### APPEAL SUMMARY

<b>Appeal ID:</b> 26330	<b>Project Address:</b> 1515 SE Miller St
<b>Hearing Date:</b> 12/8/21	<b>Appellant Name:</b> Joe Robertson
<b>Case No.:</b> B-005	<b>Appellant Phone:</b> 9712353675
<b>Appeal Type:</b> Building	<b>Plans Examiner/Inspector:</b> Kent Hegsted
<b>Project Type:</b> residential	<b>Stories:</b> 1 <b>Occupancy:</b> Residential <b>Construction Type:</b> Wood - Residential
<b>Building/Business Name:</b> Shelter Solutions LLC	<b>Fire Sprinklers:</b> No
<b>Appeal Involves:</b> Alteration of an existing structure	<b>LUR or Permit Application No.:</b> 21-108269-RS
<b>Plan Submitted Option:</b> pdf [File 1] [File 2] [File 3]	<b>Proposed use:</b> Detached ADU

**Alternate one hour assembly for West wall of existing garage conversion to ADU within three feet of property line: Granted provided:**

4	WEST.
1	1/8" = 1'-0"

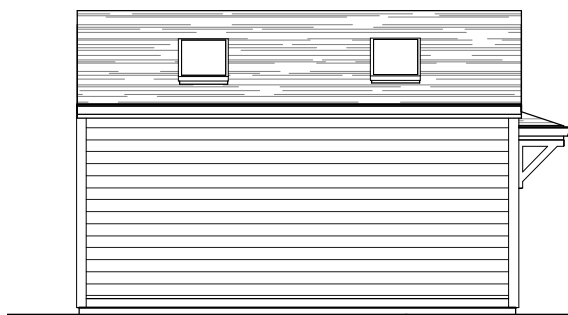
**Proposed Design** We are proposing to convert it to a detached ADU. It is 2'-6" from the West property line. We are requesting: in lieu of 5/8" type X drywall on the exterior and interior of this wall, to be allowed to install 2 layers of 5/8" type X drywall on the inside surface of the West wall up to the top of the bottom of the roof sheathing. There is not roof overhang. We proposing cutting in a cobra vent in the roof 4' from the property line for ventilation.

c. No openings including eave vents may be installed in the soffit and no openings including windows, roof vents or skylights may be installed in that portion of the wall or roof that is within three feet of the property line.

5 EXISTING WALL DETAIL  
2 1/2" = 1'-0"

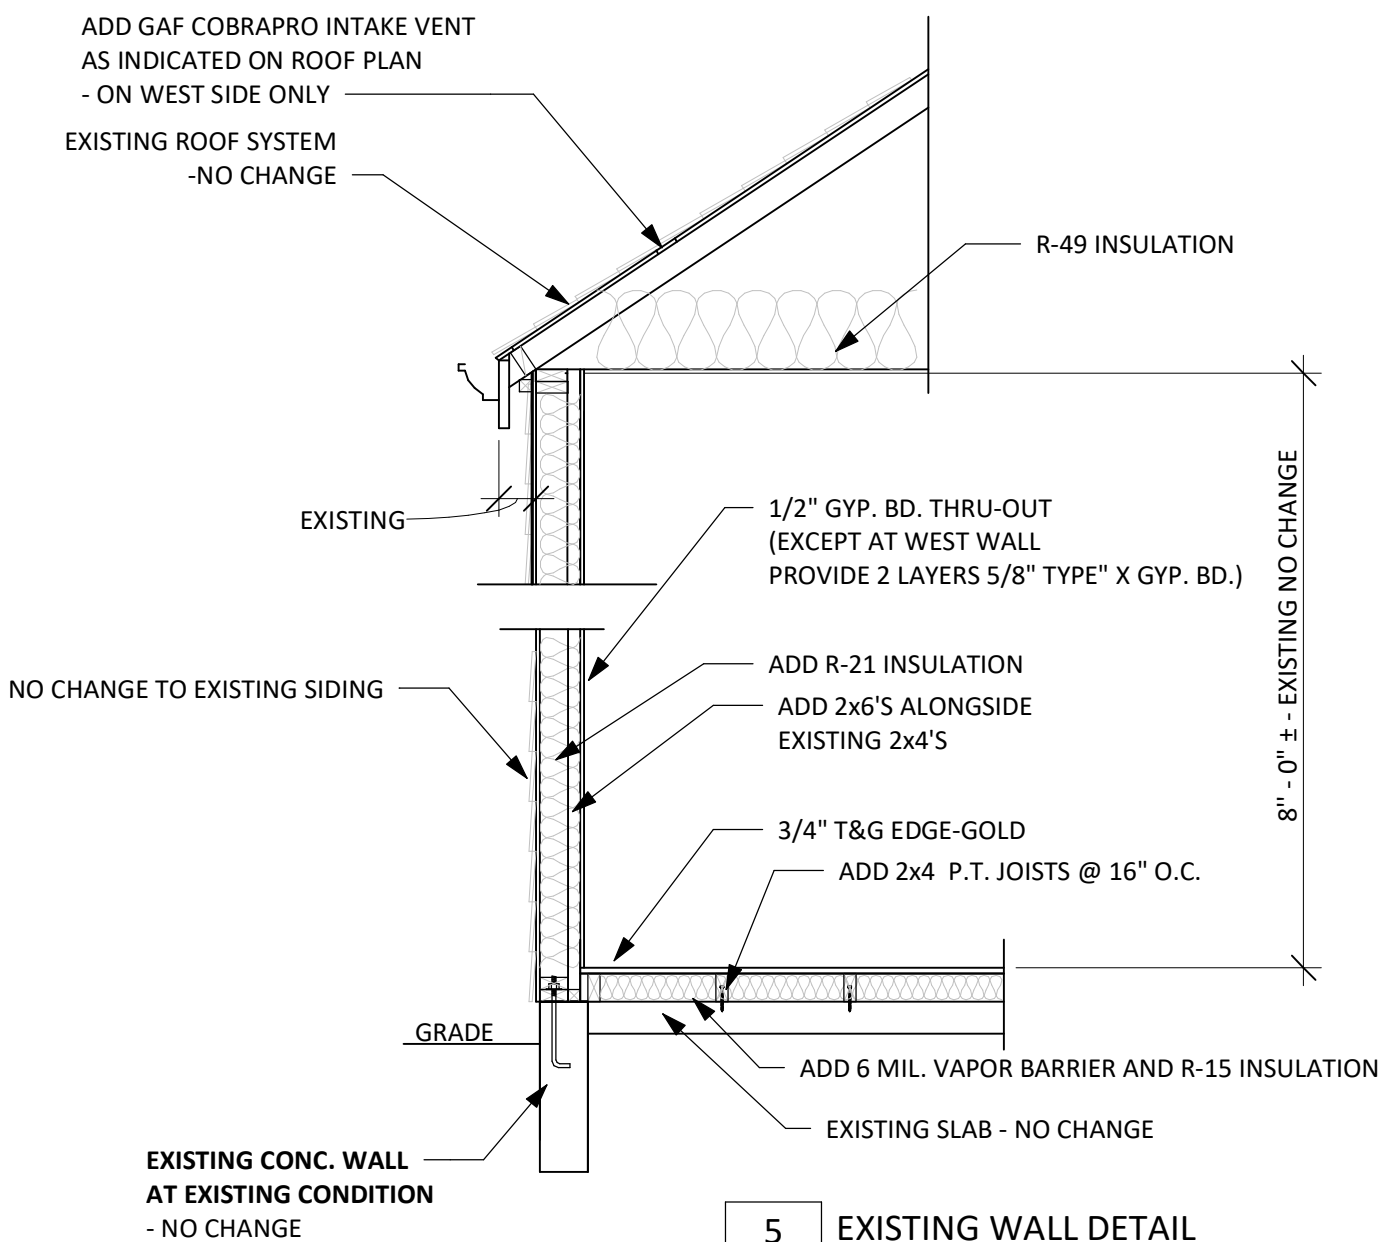
**Code Modification or Alternate Requested** Substitute an alternative method to achieve a 1 hour fire rating of an existing structure 2'-6" from the property line, to preserve the existing siding and finish on that side.

**a. Two layers of Type X gypsum are installed on the interior side of the wall continuous to the top of the**

double top plate.

b. Two layers of 2x blocking are provided between the top of the double top plate and underside of the roof sheathing, beveled where required, to fit tight against the sheathing.

d. The underside of the roof adjacent to the property line is provided with one layer of 5/8" Type X gypsum board installed directly against the underside of the roof sheathing with support provided by a minimum of 2 x ledgers attached to the side of the roof framing members for a minimum distance of four feet measured from the inside face of the finished wall surface.
